FINAL DRAINAGE PLAN

THE RIDGE AT LORSON RANCH

FILING NO. 1: SF 22-004

JANUARY, 2022
REV. MARCH, 2022

SHEET NUMBER
C9.3

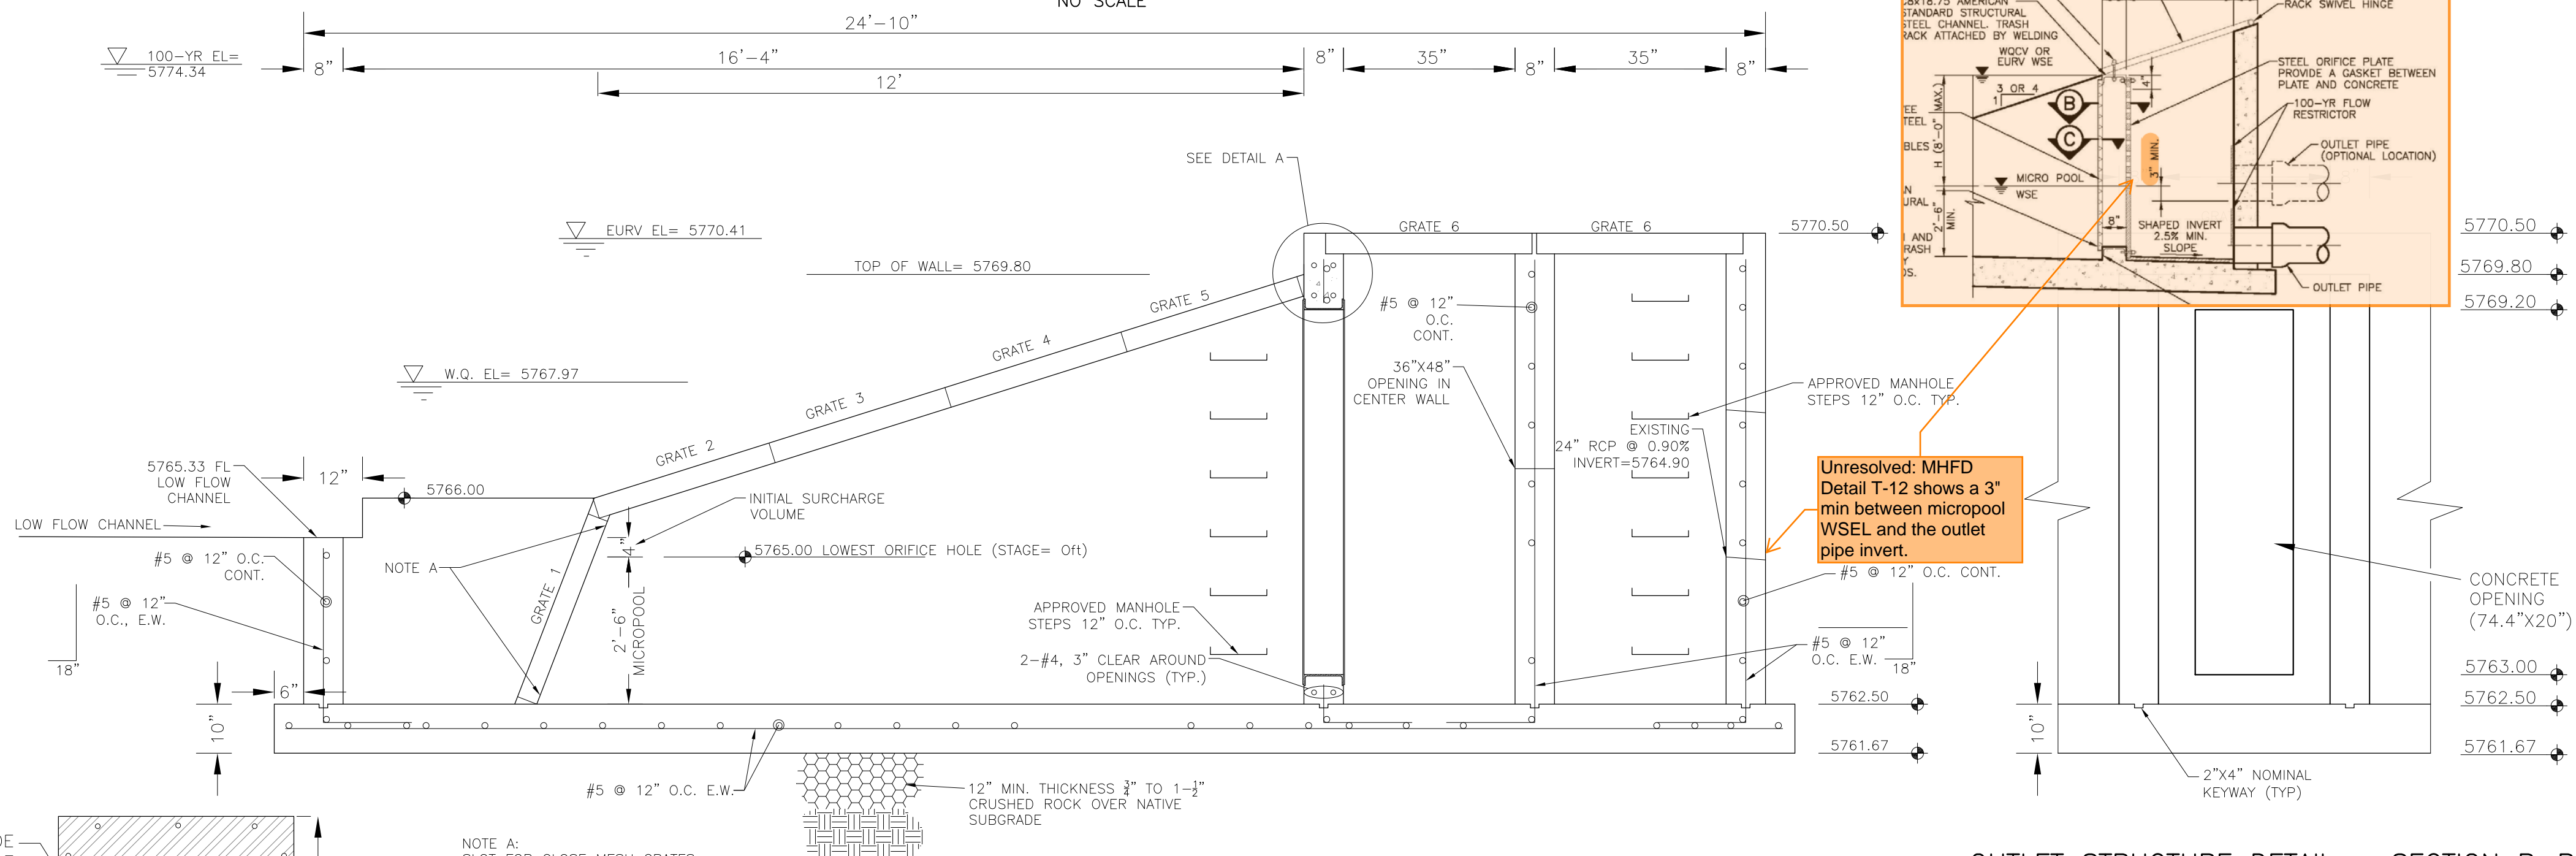
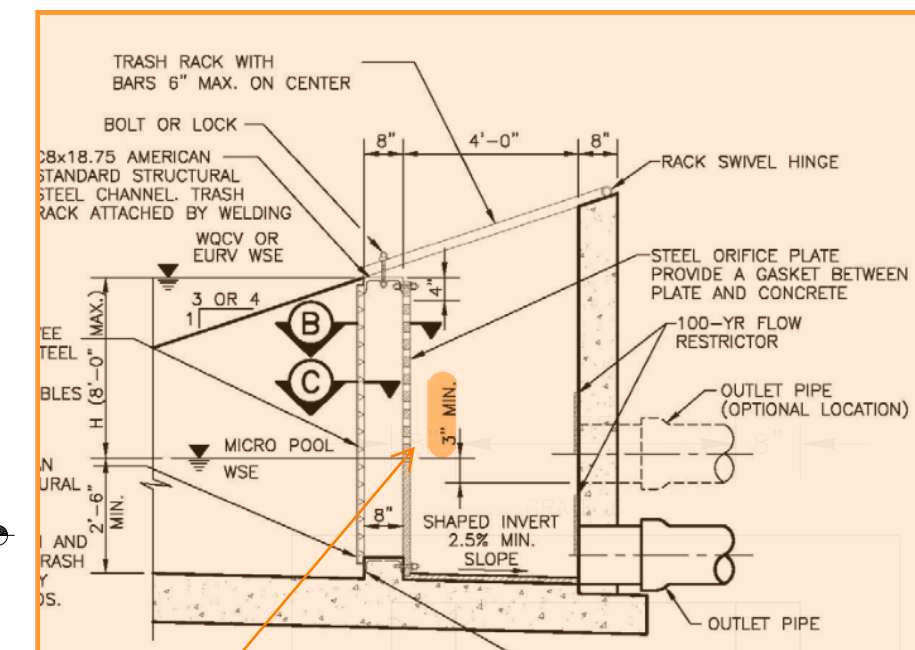
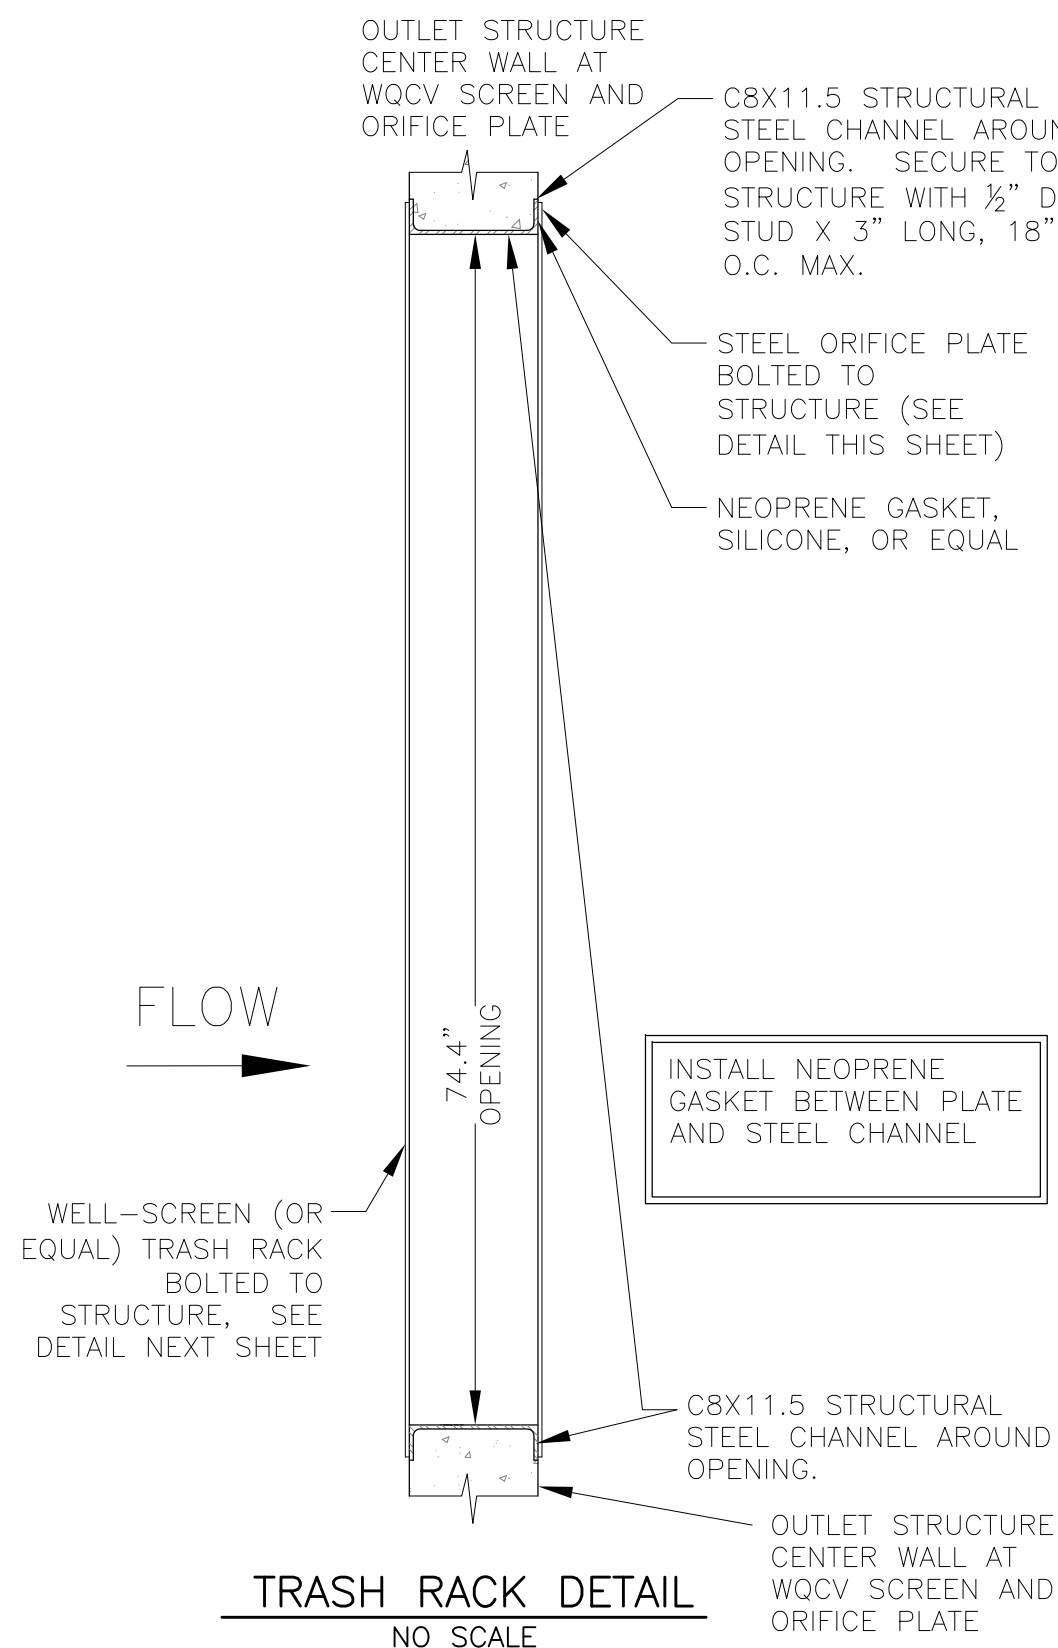
Unresolved Comment:
Sheets C9.3, C9.4, and C9 need to be included in the GEC Plans or the CD's so our SW inspectors can see them in the field. Our SW inspectors do not look at drainage reports for drawings.

Unresolved: MHFD
Detail T-12 shows a 3"
min between micropool
WSEL and the outlet
pipe invert.

SHEET NUMBER
C9.4

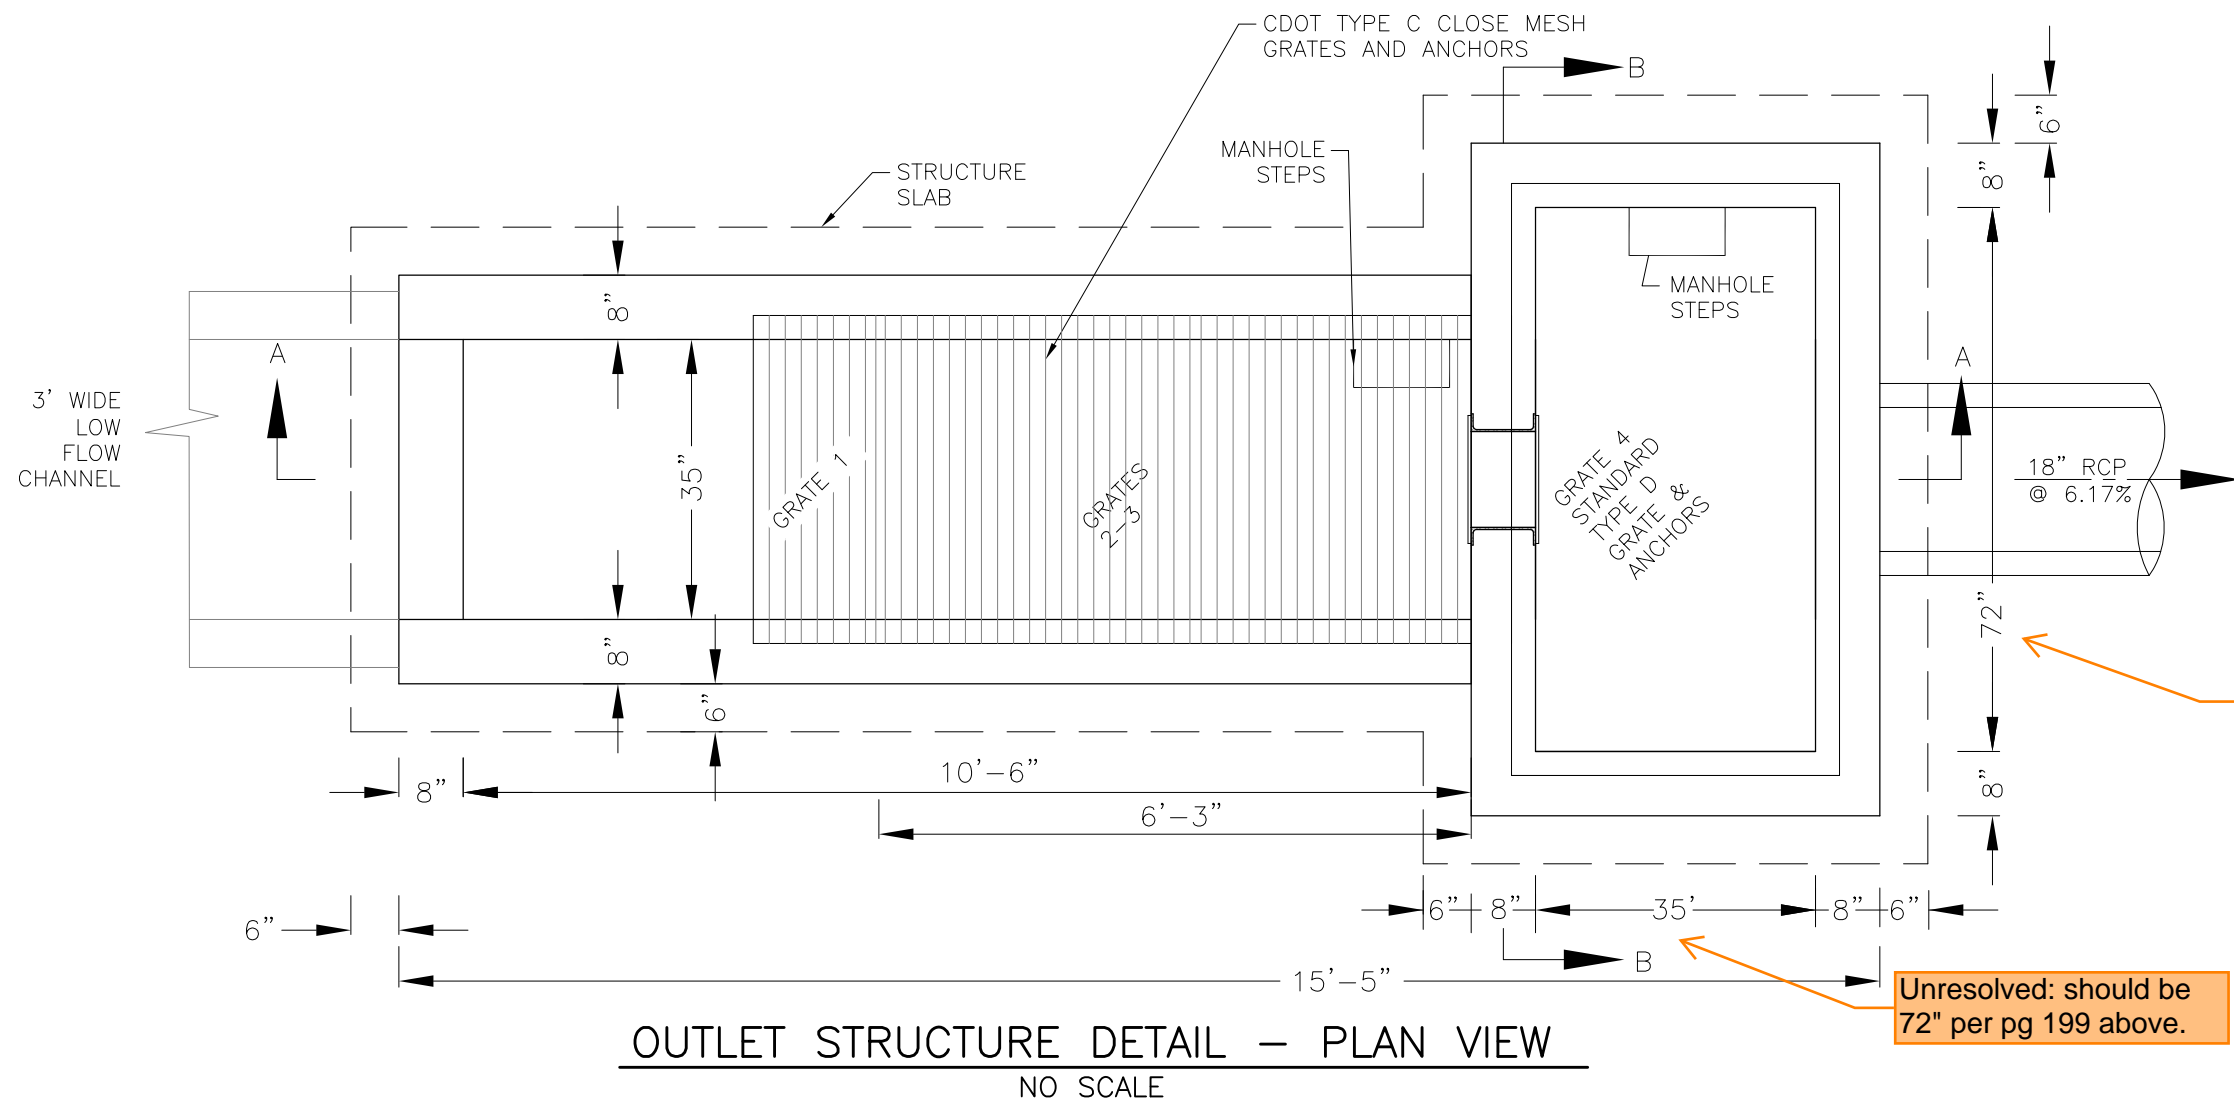
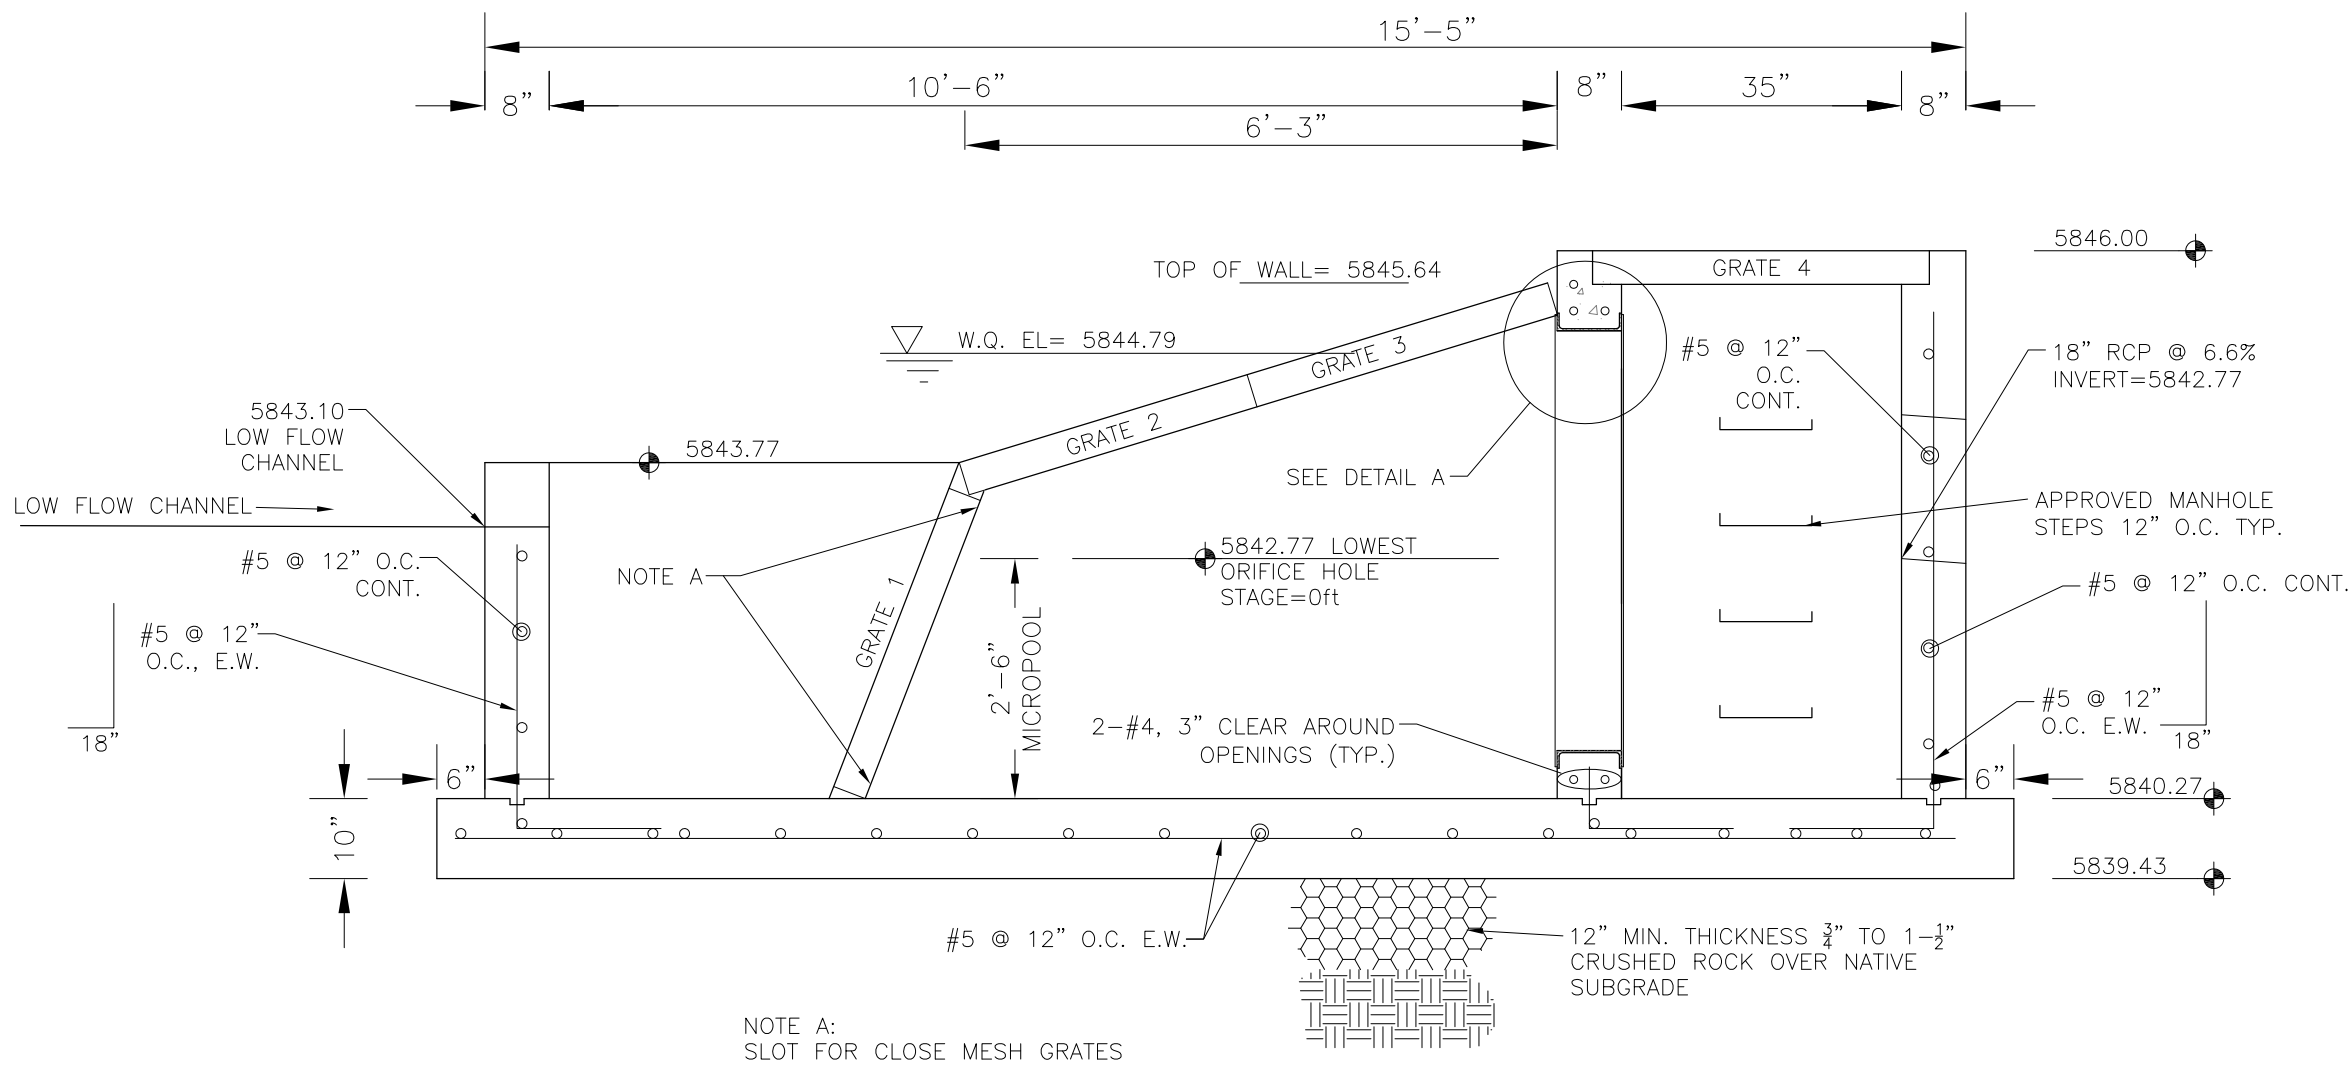
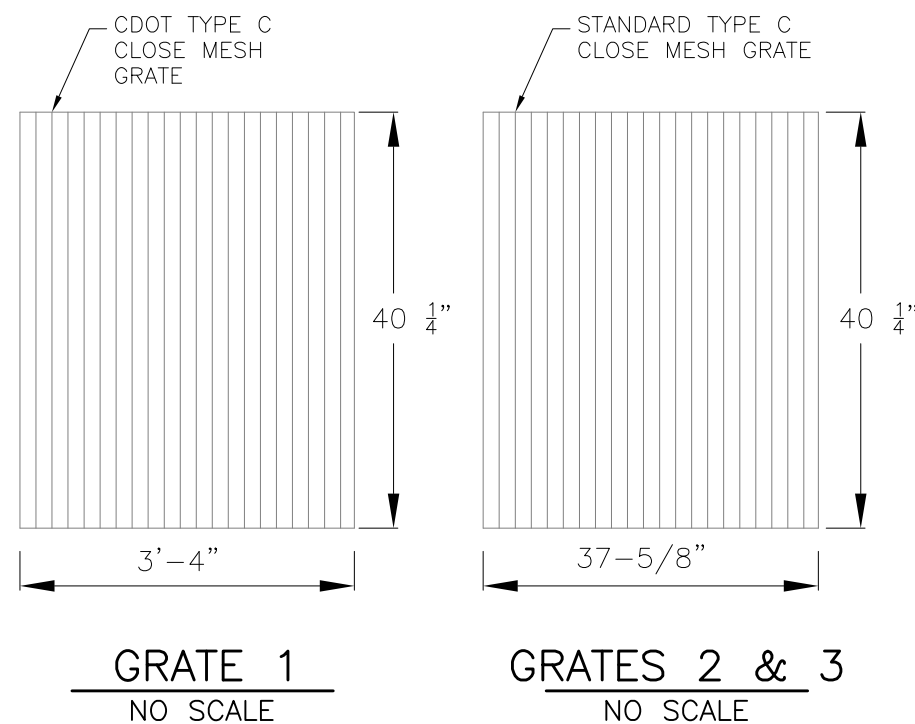
Unresolved: should be
36" per pg 199 above.

Unresolved: should be
72" per pg 199 above.

Review #2 update:
Revise outlet structure
accordingly or revise
MHFD calcs on pg 204
to reflect this outlet
configuration so there is
not a discrepancy.
